ADDENDUM #2

KITSAP COUNTY PUBLIC WORKS WASTEWATER DIVISION SILVERDALE CONVEYANCE SYSTEM AND PUMP STATION 4 UPGRADES

February 6, 2023

Drawing: **E-5C**
 Sheet: **91** of **117**
 File: P21-10530_E-5C
 Date: January 2023

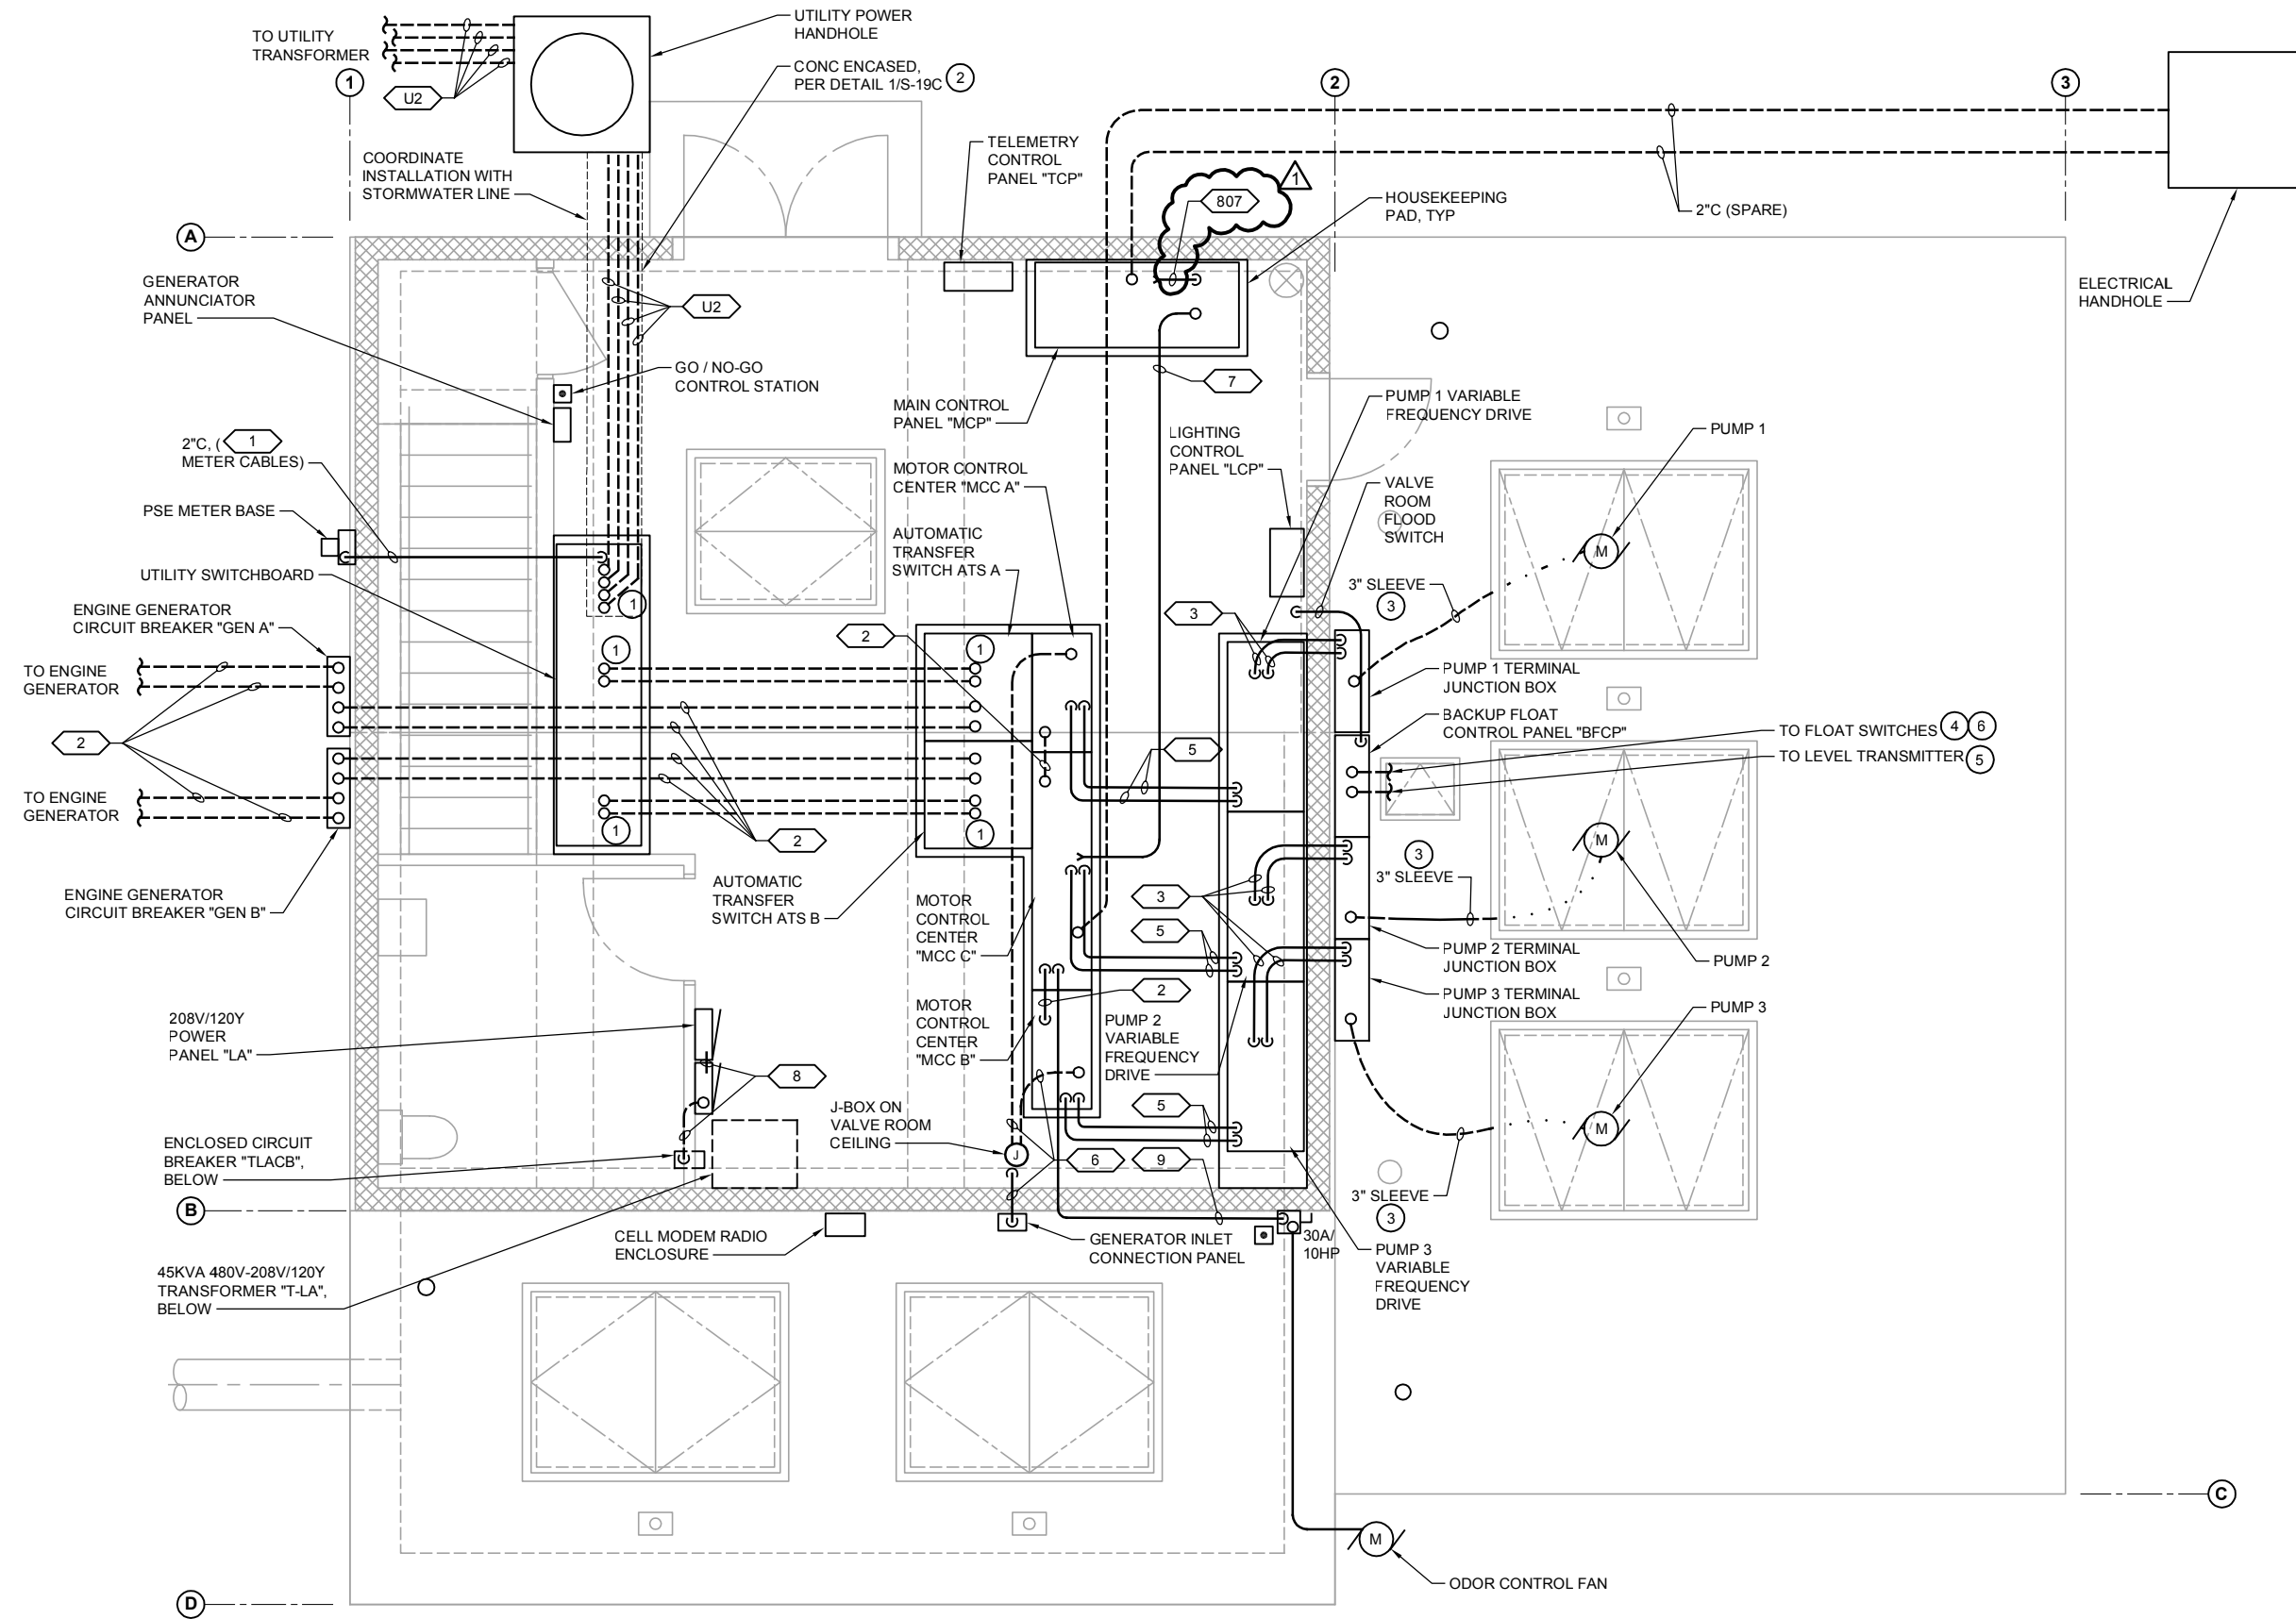
Item 7. REVISE Drawing E-5C, revise the conduit tag from the MCP as “807” instead of “8”.
